# Access Compliance Report

## Public Rights-of-Way

Intersection ID: 10036062	Main Street: RIVERGATE_PY	Cross Street: N/A	Location:	NE
ADA ID: D15FA6D894C6	Ramp Type: BlendTrans2	Initial Pass/Fail: Pass	Overall Compliance: No	Severity Score: 2.5
Codes/Mitigation Info/Possible Solution		Field Measurements/Component Compliance

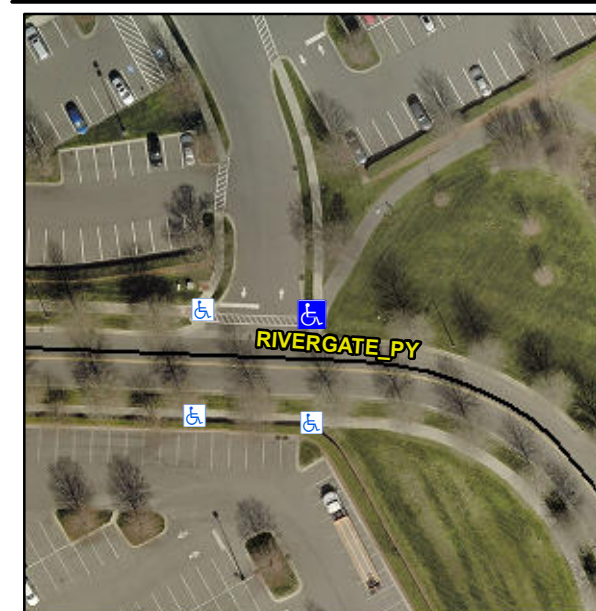
**Not Found, R305.1.4, R305.2**

Compliance	Description	Data	Compliance	Description	Data
N/A	Ramp Length (in)	128.0	Yes	BlendTrans Slope (%)	2.5
Yes	Ramp Width (in)	61.0	Yes	BlendTrans XSlope (%)	1.4
N/A	Flare Type LT	Sloped	N/A	Flare Type RT	Sloped
N/A	Flare Slope LT (%)	N/A	N/A	Flare Slope RT (%)	N/A
N/A	Flare Traversable LT?	No	N/A	Flare Traversable RT?	No
N/A	Landing Length (in)	N/A	Yes	DWS Provided?	Yes
N/A	Landing Width (in)	N/A	Yes	DWS Contrast?	Yes
N/A	Landing Slope (%)	N/A	Yes	DWS Length (in)	24.0
N/A	Landing X Slope (%)	N/A	No	DWS Full Width?	No
N/A	Landing Curb? (Y/N)	No	No	DWS Offset (in)	5.0
N/A	Shared Landing?	No			
Yes	Gutter Ponding?	No	Yes	Gutter Slope (%)	2.4
Yes	Gutter Lip Ht (in)	0.0	Yes	Gutter X Slope (%)	1.1
N/A	Painted X Walk1?	Yes	N/A	Painted X Walk2?	No
	X Walk 1 Direction	To W		X Walk 2 Direction	To S
	X Walk 1 Width (in)	49.0		X Walk 2 Width (in)	N/A
	X Walk 1 Slope (%)	1.9		X Walk 2 Slope (%)	0.8
	X Walk 1 X Slope (%)	1.8		X Walk 2 X Slope (%)	4.3

Yes	Ramp inside XWalk1?	Yes	N/A	Ramp inside XWalk2?	N/A
	Road Slope (%)	0.5		Clear Space?	Yes
	Road X Slope (%)	1.4	N/A	Clear Space to XWalk (in)	N/A
Yes	Any Obstructions?	No	Yes	Storm Grate/Utility Hazard?	No
	Obstruction Type			Storm Grate/Utility Type	
		N/A			N/A
			Yes	Surface Condition? (G/P)	Good
			No	Curb Slope (%)	18.8

**Remove & Replace Curb Ramp With Two New Directional Ramps or Equivalent.**
